2501 Richmond

September 17, 2024 - Detailed Review Letter (DR2)

Detailed Review – Outline Plan

Application Number: LOC2023-0359
Proposed Land Use Districts: DC based on Multi-Residential - High Density Low Rise (M-H1) and Multi-Residential - High Density Medium Rise (M-H2) Districts; and Special Purpose - School, Park and Community Reserve District (S-SPR)
Site Address: 2505 RICHMOND RD SW
 2519 RICHMOND RD SW
Community: RICHMOND
Applicant: Duff, Jennifer, B&A Studios
Date DTR Sent: September 17, 2024
Response Due Date: November 17, 2024

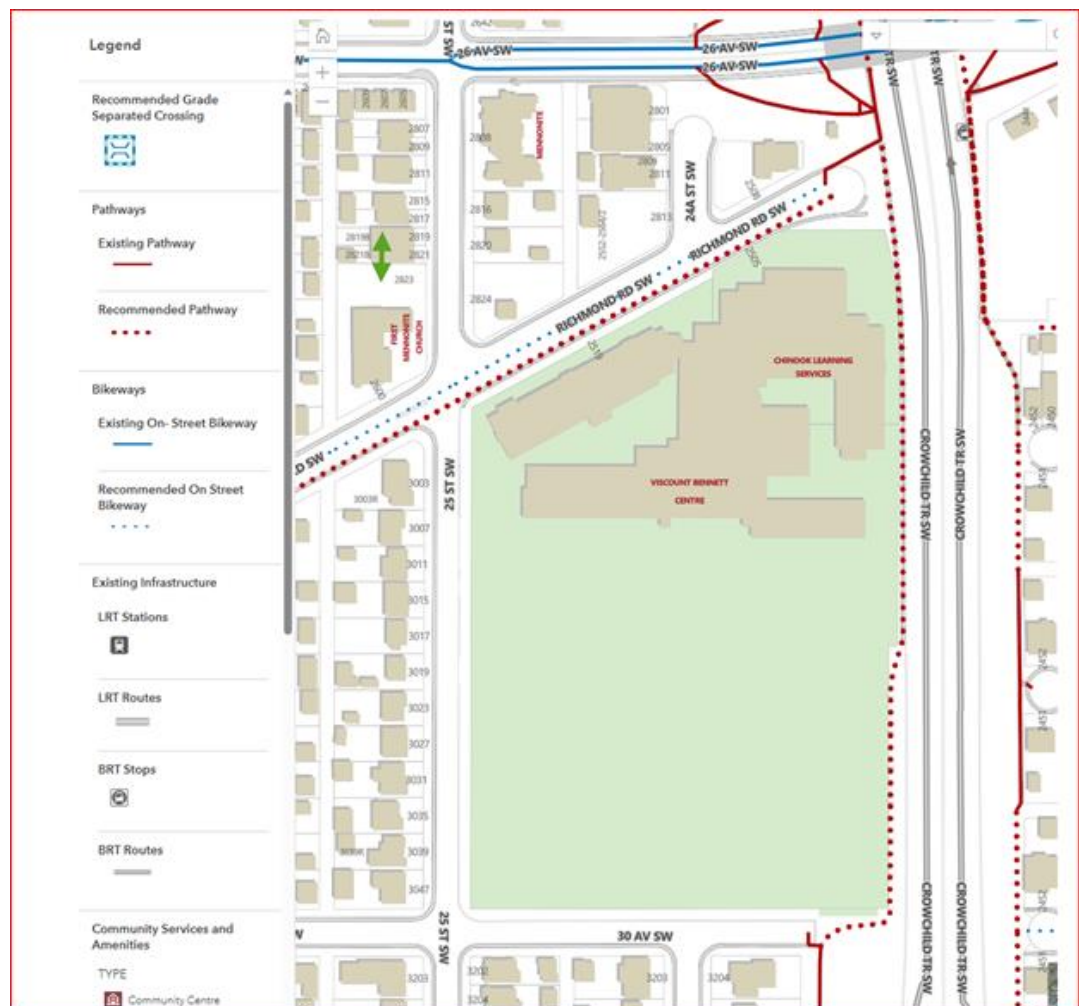
This street is part of the 5A network, which aims to provide a safe streets for everyone, whether you walk, wheel or take transit and is the ultimate goal to improve safety for pedestrians, cyclists and drivers as well as increase transportation choices for different modes and enhance the experience of using the street.

The applicant will demonstrate how the overall redevelopment project will provide connectivity to the enhanced 26 Avenue project as well as the 5A network and Transit stops. See Illustration below.
